Type of Report: Committee
Council: 23 April 2018
Expiry Date: 23 April 2018
Application No: PLN-17-12
Address: 46 FEDERAL STREET , NORTH HOBART
Applicant: JEFFREY ALLAN DAVIS
46 FEDERAL STREET
Proposal: Alterations, Extension and Change of Use to Multiple Dwelling
Representations: Five (5)
Performance criteria: Inner Residential Zone Development Standards and Parking and Access Code

1. Executive Summary

Figure 10: Original Proposed Site Plan.

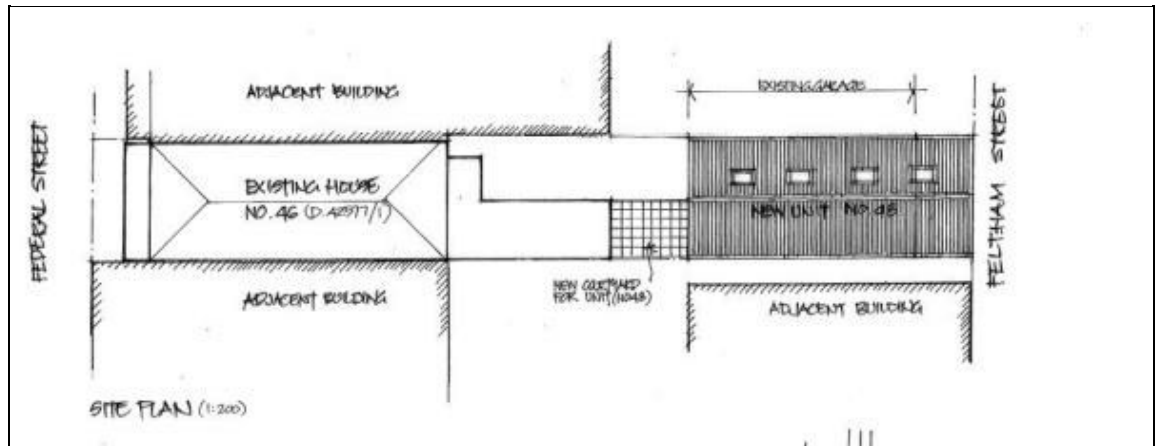
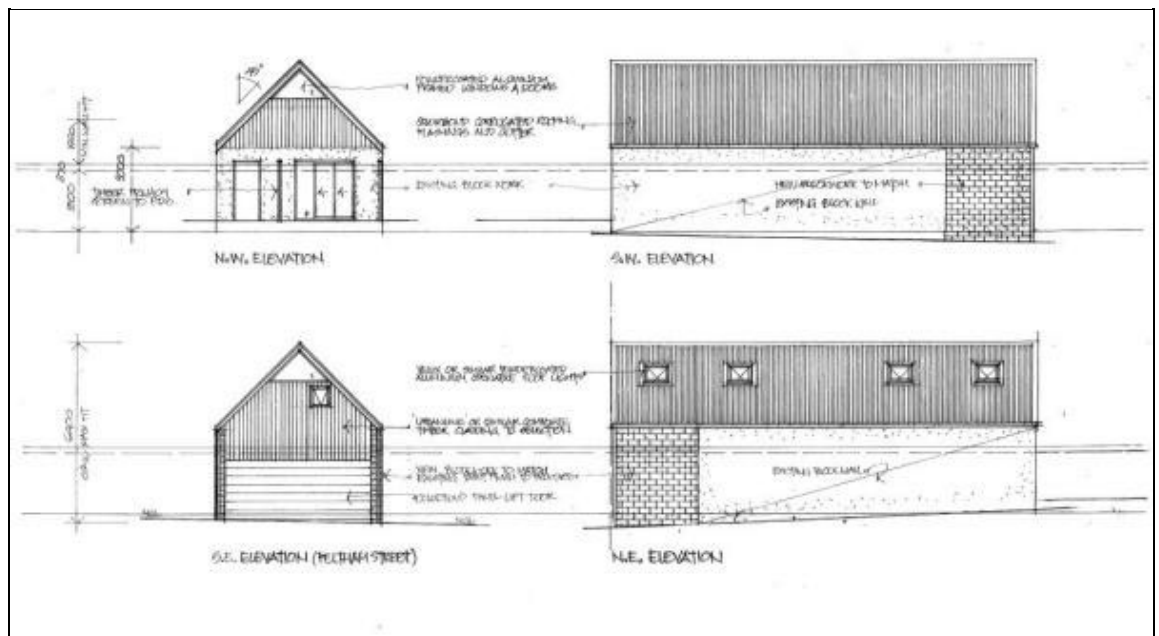
- 4.1 The original proposed design for the dwelling featured the extension of the existing garage structure to the front boundary as shown in the images below. The original proposed design received two representations when advertised in April 2017.

4.2 Council officers raised concerns with the applicant about the impact of the section of the proposed building extending towards the street on the sunlight into the window of the adjoining building at 51 Feltham Street (refer images 4 and 5 above). The applicant was informed that the original proposed design would not be supported by officers.

In response to officer concerns, the applicant submitted an amended design that proposed that the dwelling be contained within the existing footprint of the garage building. The existing garage walls would also be lowered from the 3.3m maximum height to 3m and the roof form altered to remove the peak of the gable allowing greater light penetration to the adjoining property beyond that of the permitted envelope. To allow for habitable space in the roof, the angle of the north eastern side was increased to 67.5 degrees. The amended design is shown below:

Figure 12: Amended design site plan.

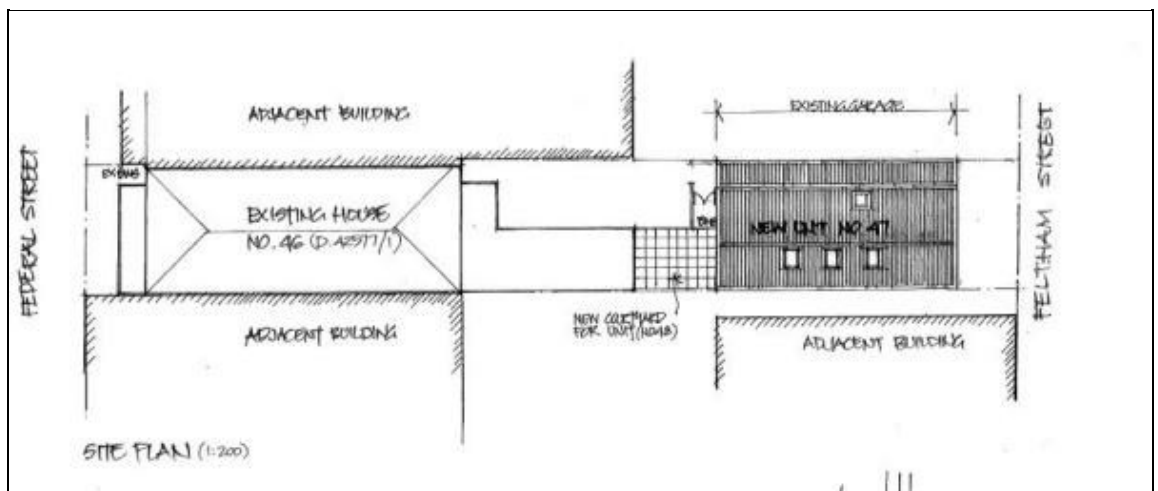
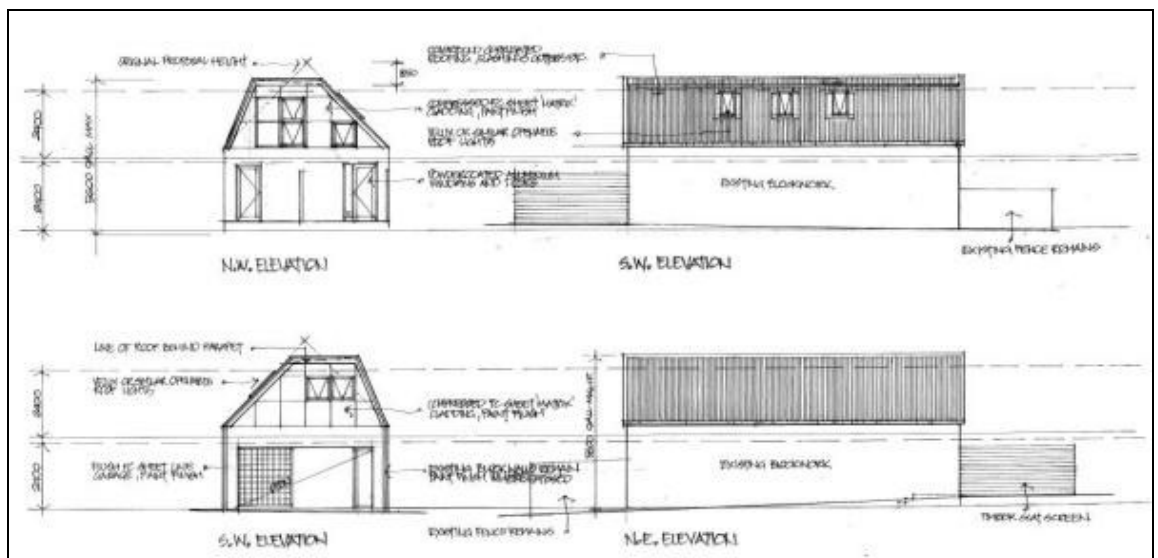
4.3 The amended design was re-advertised in October 2017 and received five (5) objections. The amended design is considered supportable in respect of the planning scheme requirements (refer to assessment below). In an effort to address additional concerns raised by representors, the applicant has offered further amendments to the proposal and provided the following statement:

6.8.2 The proposed roof section on the north eastern side of the dwelling is outside the envelope due to its 67.5 degree angle. Also, due to site containing existing buildings within 1.5m of the side boundary, the proposed new roof sections of the dwelling that are within 1.5m of the side boundary are cumulatively in excess of a total length of 9m.

- *The windows from the upstairs hallway and staircase on the NW elevation will be opaque so as to improve privacy for 48 Federal Street and the existing dwelling on 46 Federal Street.*
- *The proposed roof pitch has been lowered by 5 degrees to 62.5deg on the Northern side. The roof line remains at 850 mm under the maximum height as defined by the building envelope.*
- *The specification for the roof material has been changed to "Matte Colorbond" so that glare can be minimized for surrounding properties.*

Figure 14: Amended roof angle offered by the applicant and to be required by condition.

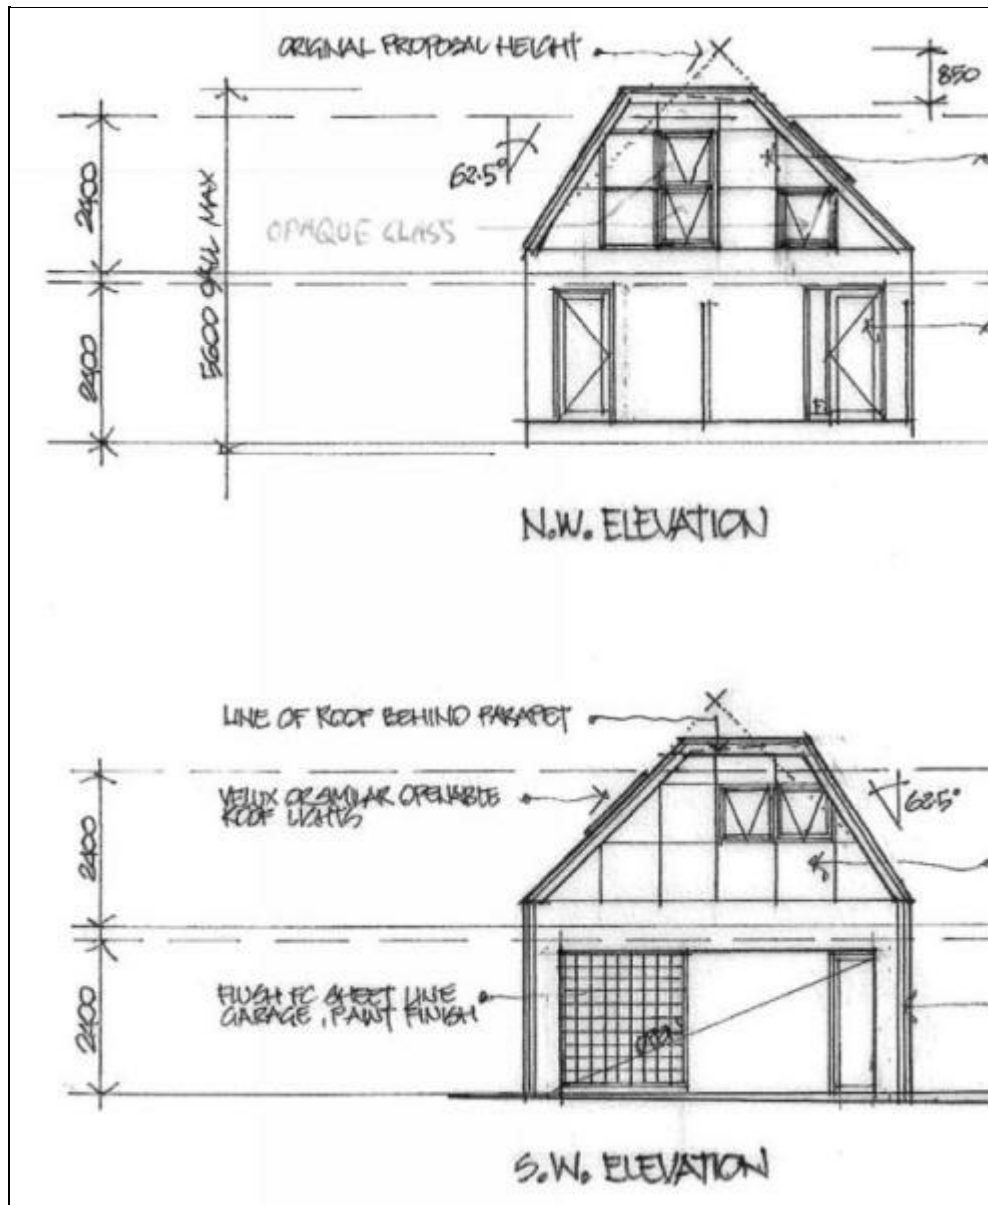
The above additional amendments can be required by conditions on the permit. The proposed additional amendment to the roof angle is shown below.

The angle of the north-eastern side of the proposed roof must be reduced 62.5 degrees.

Figure 15: The red line is an indicative representation of the applicable permitted building envelope. Note that up to 3m on each side boundary,

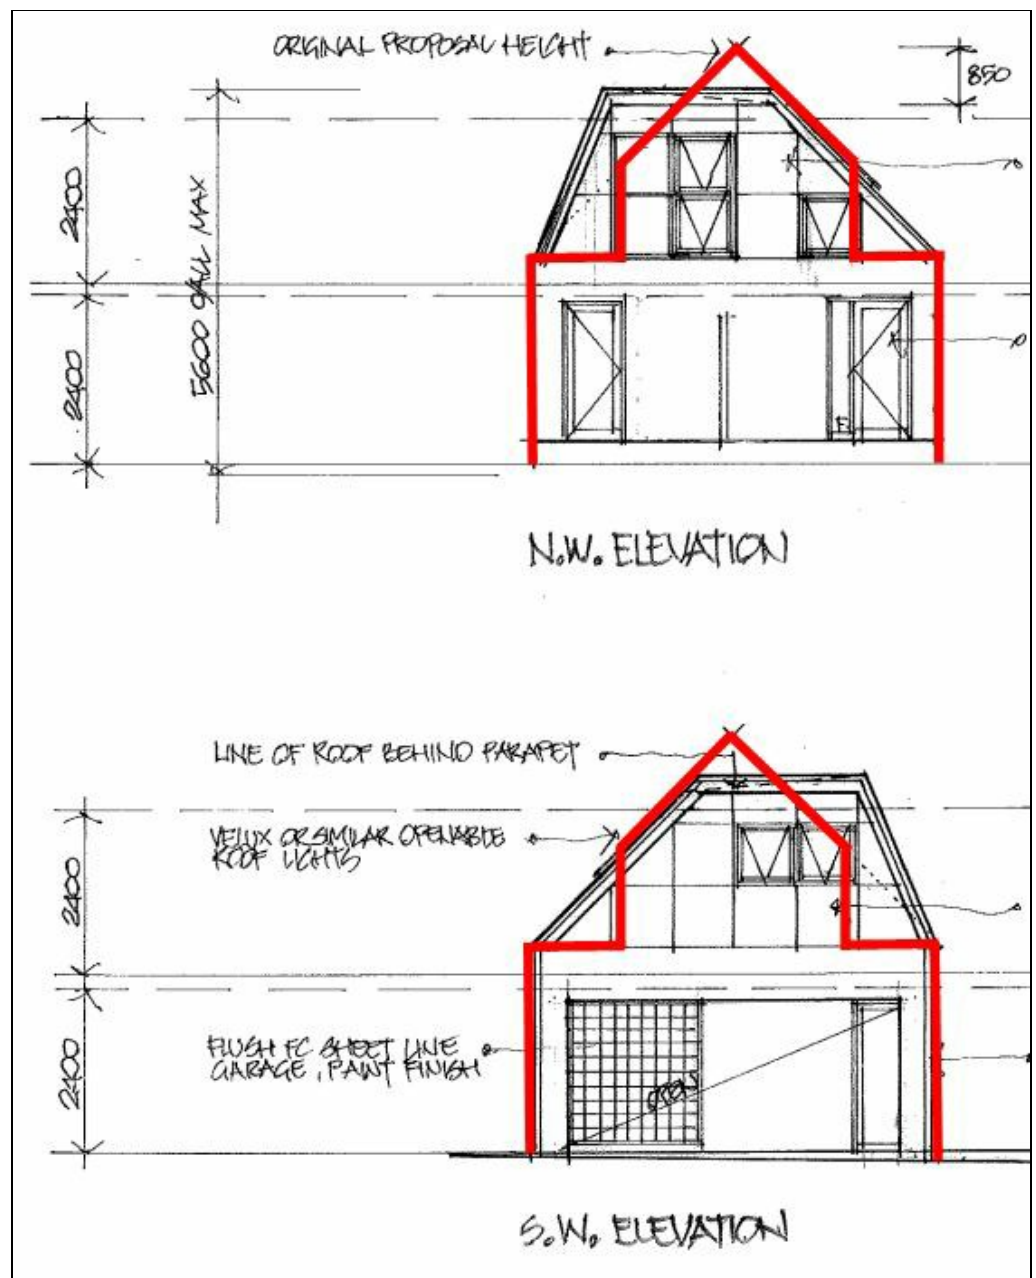
- 6.8.5 There are two aspects to the proposed building envelope discretion - the section of the proposed roof that is within 1.5m of the boundary and the part of the top section of the gable roof that exceeds the prescribed building envelope's 45 degree angle. The image below is indicative of how the prescribed building envelope and the 1.5m setback apply to the building:

Firstly, the triangle sections created by the 1.5m setback requirement have no tangible impact in terms of shadowing of the property to the south-west at 51 Feltham Street, as they are inset from the upper section of the roof, which is within the envelope. The removal of the gable peak (although within the permitted building envelope) and the lowering to 3m of the existing blockwork walls on the boundary will allow improved solar access. In terms of the visual impact created by these sections of the roof, the proposal will present an improved outcome due to the lowering of the blockwork wall on the boundary, which is currently at the same approximate height as the top of the windows, as seen in the image below:

Figure 17: Proposed reduced roof angle by applicant

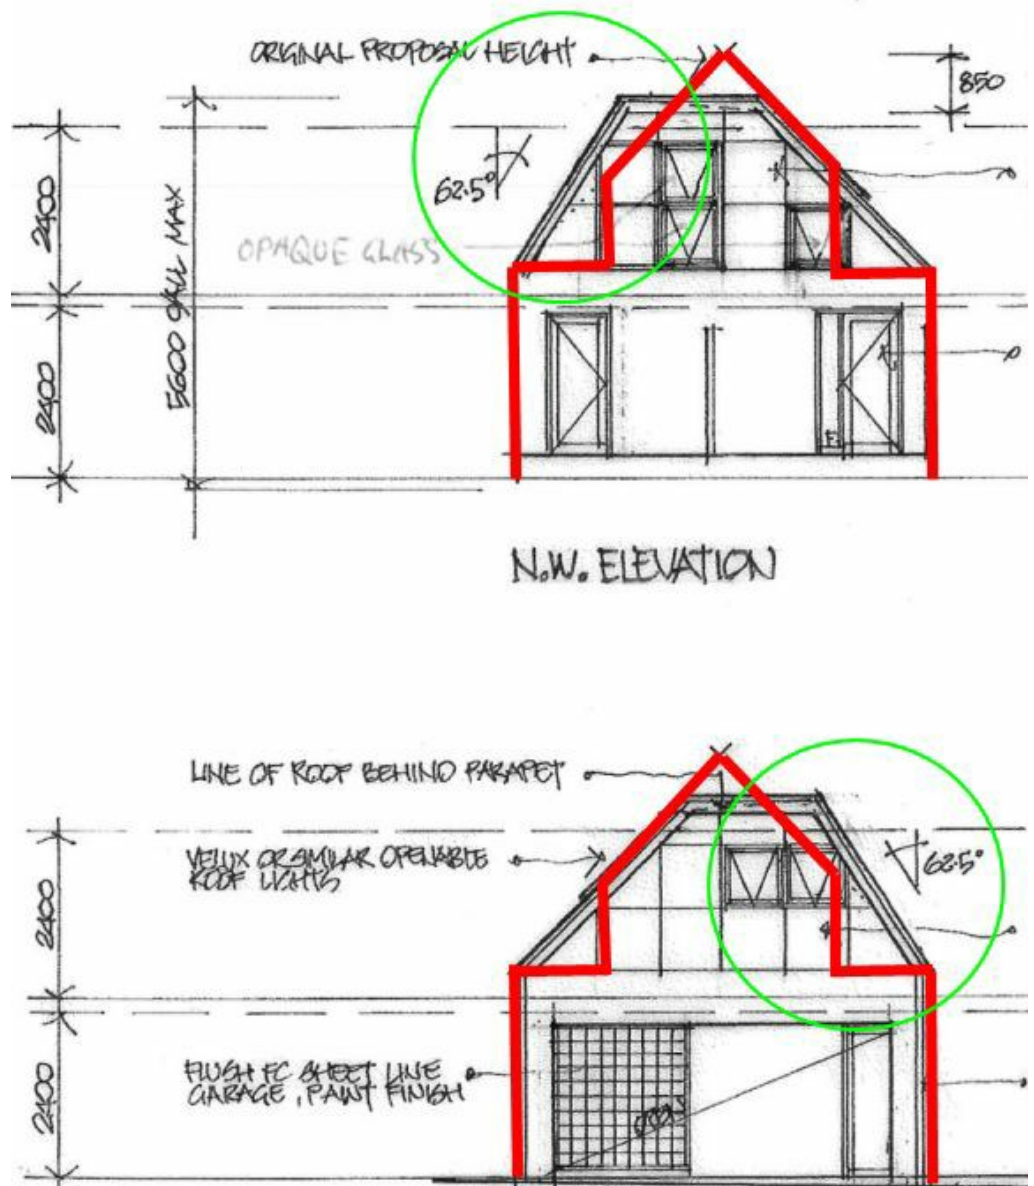
In respect of the encroachment of the roof on the north eastern side, the

The proposed reduced roof angle leaves a very narrow sliver of roof outside the envelope and the 1.5m inset triangle sections as demonstrated in Figure 15 above. Irrespective of the encroachments, the majority of the adjoining property at 44 Federal Street is to the north and east of the subject site. Only the late afternoon sun to the rear of this neighbour will be affected, which is already affected by the existing garage wall, and in addition this impact is largely onto the neighbour's parking area. The minor variance of the angle of the roof from the permitted 45 degrees to 62.5 degrees (17.5 degrees) will only result in a brief additional impact to this area before the sun moves behind the
